SUBJECT: Provides partial response to request for addl info re I
 Generic Ltr 88-01, "NRC Position on IGSCC in BWR ASSP." D

SUSQUEHANNA STEAM ELECTRIC STATION
ADDITIONAL RESPONSE TO GENERIC LETTER 88-01
PLA-3233 FILE R41-1D

The following is our partial response to the request for additional information regarding Generic Letter 88-01, "NRC Position On IGSCC In BWR Austenitic Stainless Steel Piping." The following items are included in our current response:

Figure 3-4. Recommended Corrosion Crack Growth Rates, for Austenitic Stainless Steel: Curve A - Furnace Sensitized Material, 0.2 ppm Oxygen; Curve B - Weld Sensitized Material, 0.2 ppm Oxygen

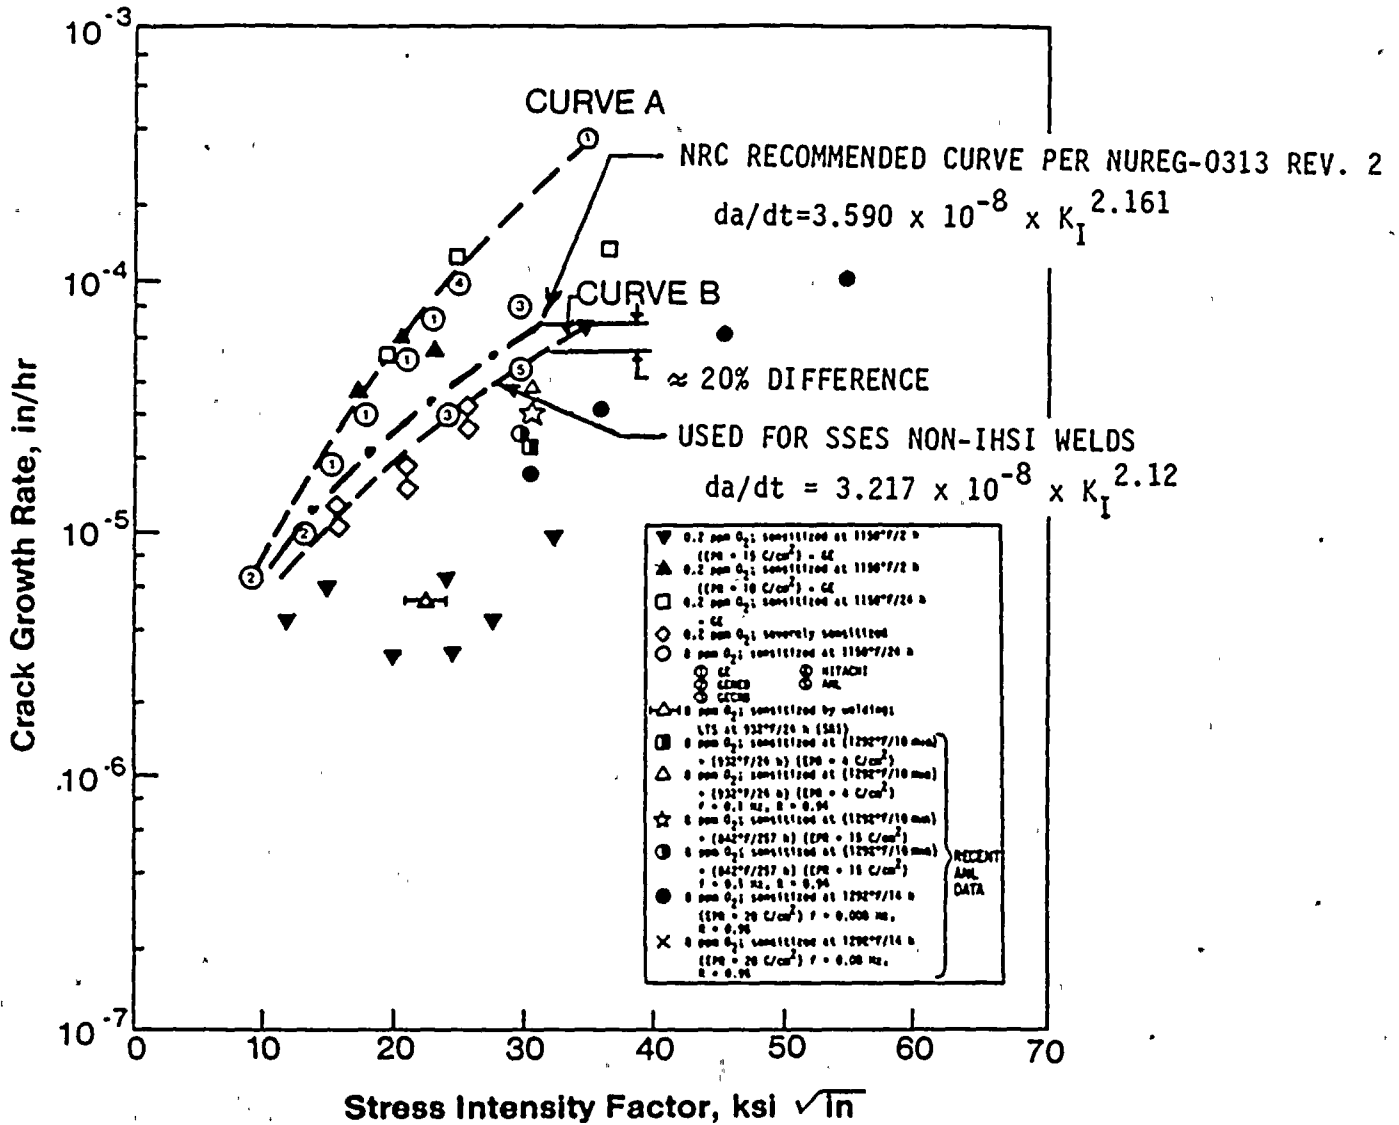
- a) The reasons why an equation is used for non-IHSI welds that gives about 20% lower crack growth rate than that for IHSI welds are as follows:
1. The crack growth equation for non-IHSI welds was taken from data compiled by R. M. Horn and co-workers and presented in EPRI Report NP-4690-SR as Figure 3-4 (copy attached). This report summarizes the methods and bases used by the Task Group for Piping Flaw Evaluation to develop allowable flaw sizes for Section XI, IWB-3640 of the ASME Code. The equation used for the non-IHSI welds represents Curve B-Weld Sensitized Materials, 0.2 ppm Oxygen, in Figure 3-4. This curve gives results about 20% lower than the crack growth rate selected for use by the Staff in NUREG-0313, Revision 2.

2. As noted above, the crack growth equation for Curve B represents weld-sensitized Type 304 stainless steel behavior in 0.2 ppm oxygenated water. We note that this equation differs slightly from that used by the NRC since each equation was based on the engineering judgements of two different organizations, specifically the ASME Code Section XI and the Nuclear Regulatory Commission. In our judgement, we believe that the use of Curve B is justified due to the conservatism in our analysis model for the non-IHSI welds. The primary conservatism in our evaluation for these welds is the assumption of a full 360 degree ID flaw. This assumption becomes very conservative for evaluating finite length flaws with aspect ratios larger than one to ten.

Figure 3-1. Measured Axial Throughwall Residual Stress as a Function of Radial Distance Through the Pipe Wall for Austenitic Stainless Steel Pipe Welds

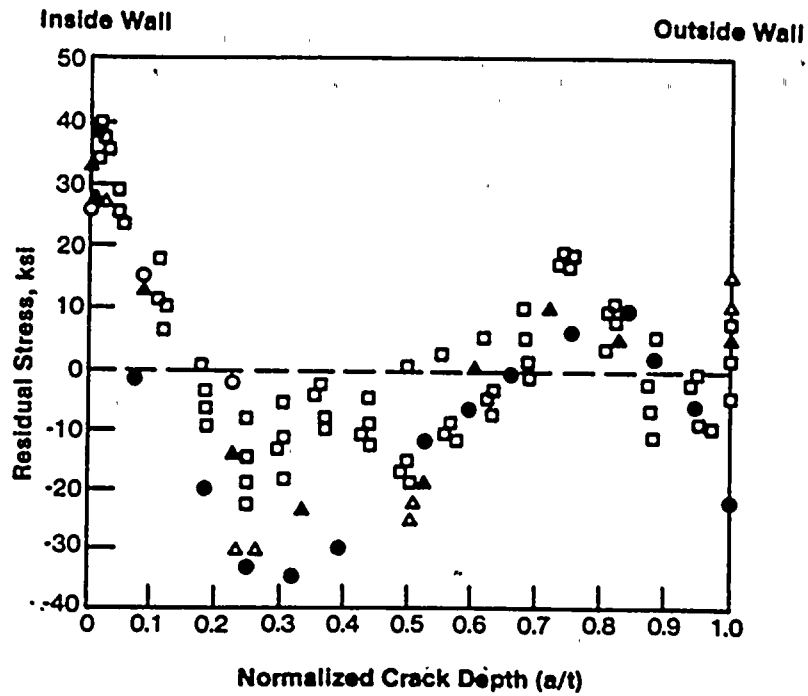
- b) The residual stress distribution for welds in pipes with wall thicknesses < 1 inch is also based on recommendations of the Task Group on Piping Flaw Evaluation contained in EPRI report NP-4690-SR. (Reference Figures 3-1 and 3-3). The data contained in this report suggest that residual stress differences in various sizes of pipe are due primarily to the increased heat capacity of thicker wall pipe and are only coincidentally associated with diameter. Consequently, a linear distribution is used for thinner wall pipe due to its decreased heat capacity. The linear distribution will provide a conservative representation of residual stress for ID flaws in thin wall pipe. The transition to a non-linear distribution was chosen somewhat arbitrarily at one inch. Both finite element calculations and limited experimental data support these different residual stress distributions.
